GROUNDWATER MONITORING PLAN
COMMENT/RESPONSE REPORT
LENA ROAD LANDFILL
PERMIT NUMBER 5041-211176
BRADENTON, MANATEE COUNTY, FLORIDA
PSI PROJECT NO. 378-4L015

Re: Groundwater Monitoring Plan
Comment/Response Addendum Report
Lena Road Landfill
Permit Number 5041-211176
Bradenton, Manatee County, Florida
PSI Project Number: 378-4L015

**GROUNDWATER MONITORING PLAN
COMMENT/RESPONSE ADDENDUM REPORT
LENA ROAD LANDFILL
PERMIT NUMBER 5041-211176
BRADENTON, MANATEE COUNTY, FLORIDA**

DATE FEB 95 PROJ. NO. 378-4L015 FIGURE 2

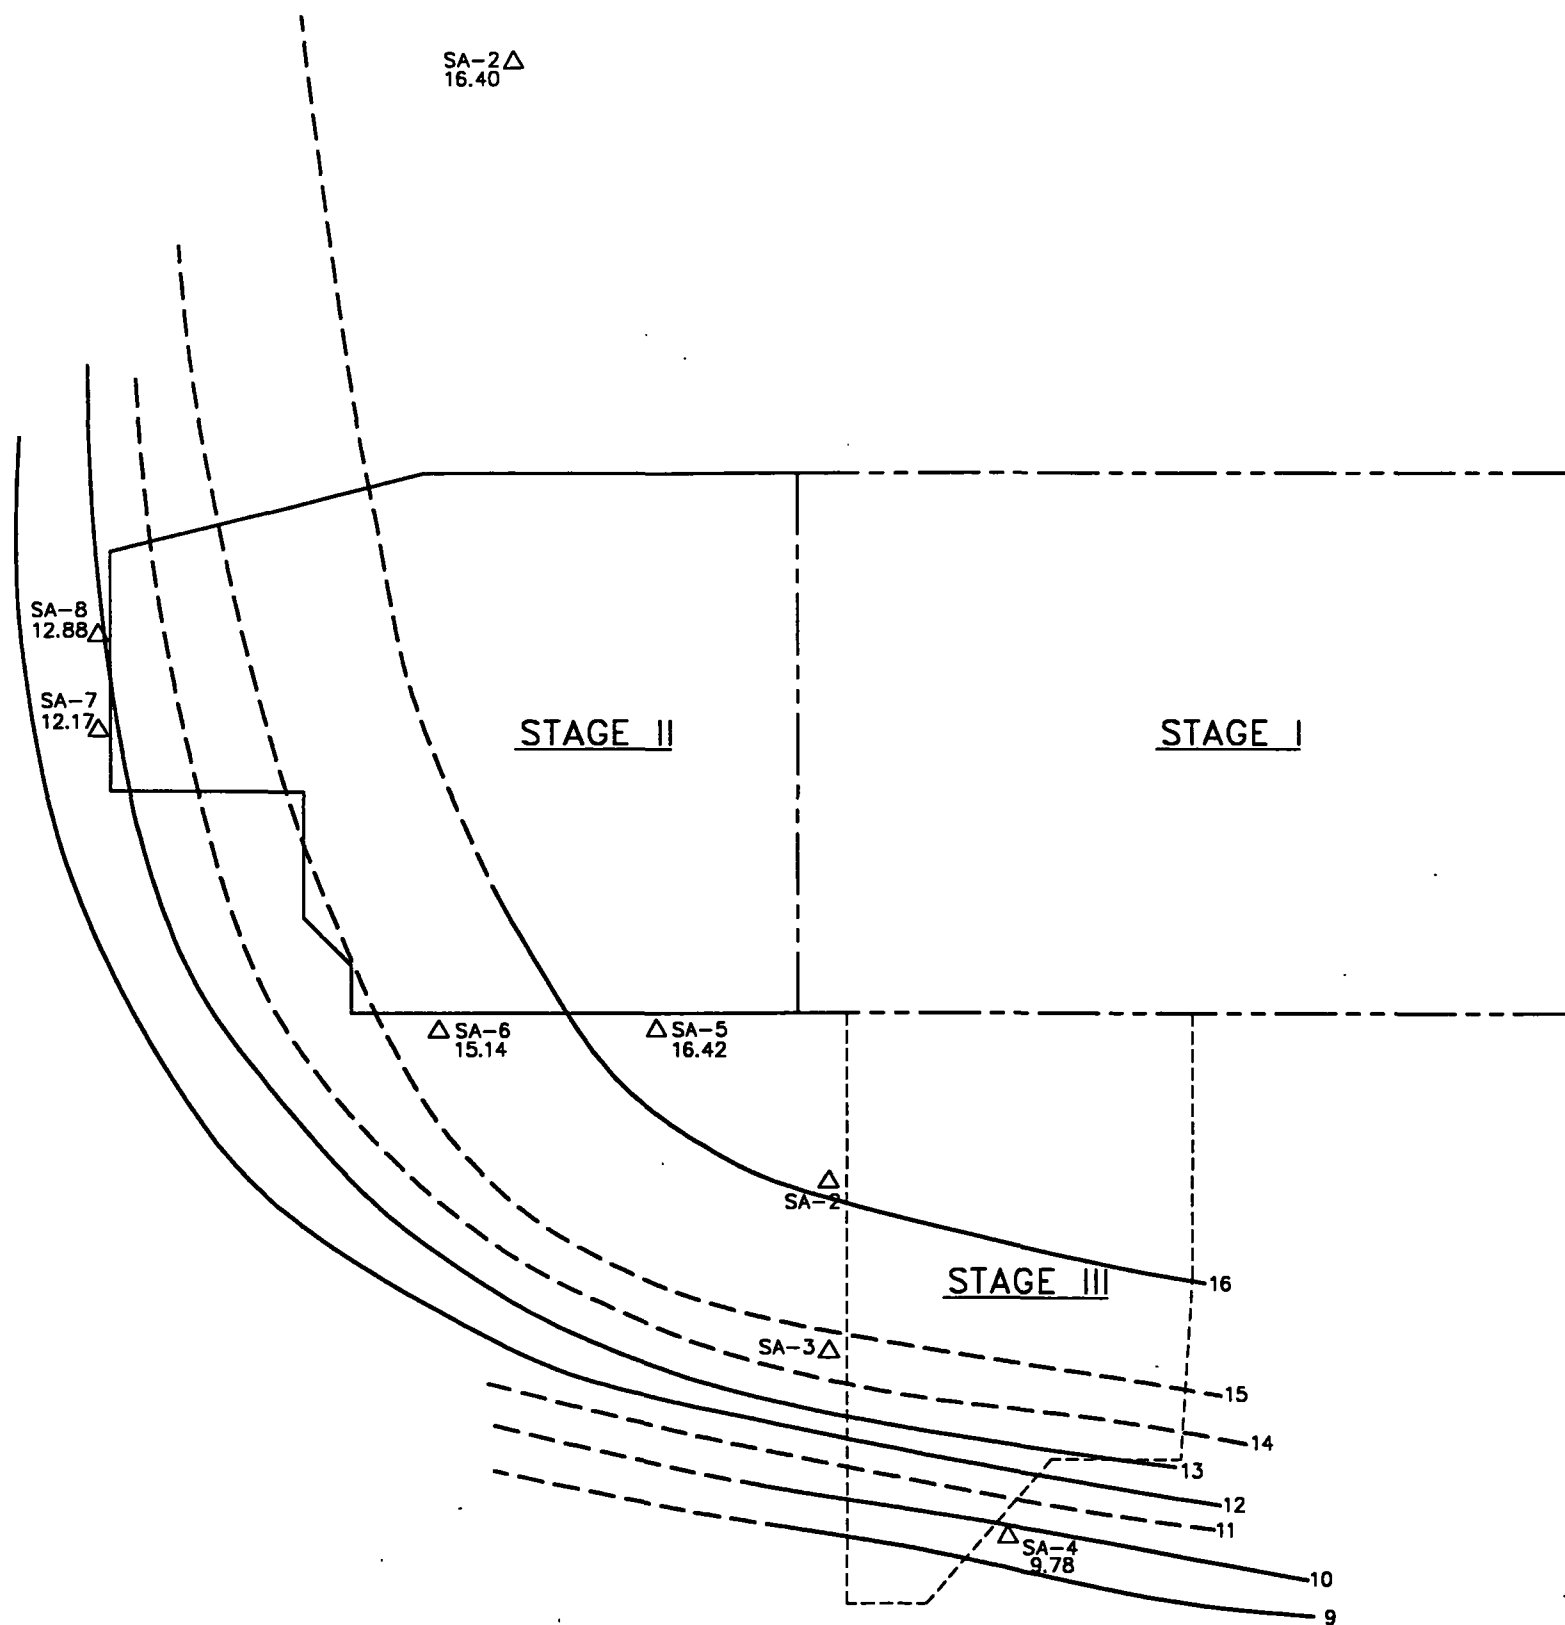
- Map with the location of the deep wells.
- Groundwater flow in the deep aquifer.
- Vertical gradient at the site.
- Map showing the location of all the filled areas inside, and outside of the slurry wall. From discussions with Greg Yekaitis, Manatee County Solid Waste Administrator, there are old waste-filled areas outside of the slurry wall that may impact the current facility's groundwater monitoring program.
- In addition, a base map showing the location of all wells would be useful.

- In addition, a base map showing the location of all wells would be useful.

- A map with the location of the deep wells is provided in Appendix C, Figure 2, of this report.
- PSI has evaluated the data concerning the deep wells at the Lena Road Landfill and interpret the direction of groundwater flow to be to the north-northwest. There is a general trend for the high point to be in the vicinity of deep monitoring well SA-5, and for the low points to be in the area of deep monitoring wells SA-4, SA-7, and SA-8. The data is limited to the six (6) similarly constructed wells and is meant to give a rough estimate of groundwater flow direction. This data does correlate well with the regional trend of groundwater flow published by Southwest Florida Water Management District. Groundwater contour maps for the deep monitoring wells are provided in Appendix C, Figures 8-15 of this report.

- It is PSI's understanding that a map showing the location of all the filled areas inside and outside of the slurry wall will be provided to the FDEP by Mr. Greg Yekaitis, Manatee County Solid Waste Administrator.
- A base map showing the location of all wells and piezometers is provided in Appendix C, Figure 2, of this report.
